# **Pentium<sup>®</sup> II Processor Specification Update**

Release Date: July 1997

Order Number: 243337-003

B. *Expected Response*

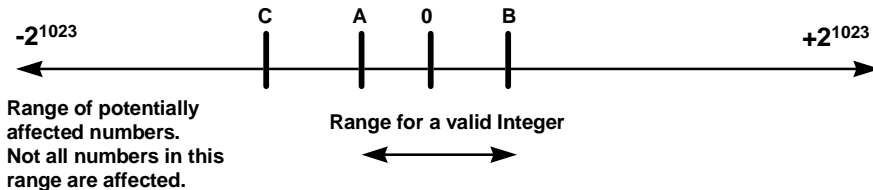
**PROBLEM:** On certain, large, negative, floating-point operands, and only in three of the four possible processor rounding modes, the instructions FIST[P] m16int and FIST[P] m32int do not detect that the operand is so large that it will not fit into the target data size. As a consequence, the expected Invalid Operation exception response for this situation is not correctly provided, nor is the Invalid Operation flag set in the Floating Point status word as specified in the *Intel Architecture Programmers Reference Manual, Volume 2*. Under the failing conditions, noted below, the precision exception (#PE) will also be incorrectly set.

A. *Actual Response:*

- Return the MAXNEG value (8000h for FIST16 & 80000000h for FIST32) to memory.
- The IE (Invalid Operation) bit in the Floating Point status word is *not set* to flag the use of an invalid operand.
- The PE (precision error) bit the Floating Point status word is *set*.
- No exception handler is invoked.
- In the case of a FISTP instruction the Operand will have been popped from the floating point stack

The expected processor response when the invalid operation exception is *masked* is:

- Return the MAXNEG value (8000h for FIST16 & 80000000h for FIST32) to memory.
- The IE (Invalid Operation) bit in the Floating Point status word is *set* to flag the overflow.
- The PE (precision error) bit the Floating Point status word is *not set*.
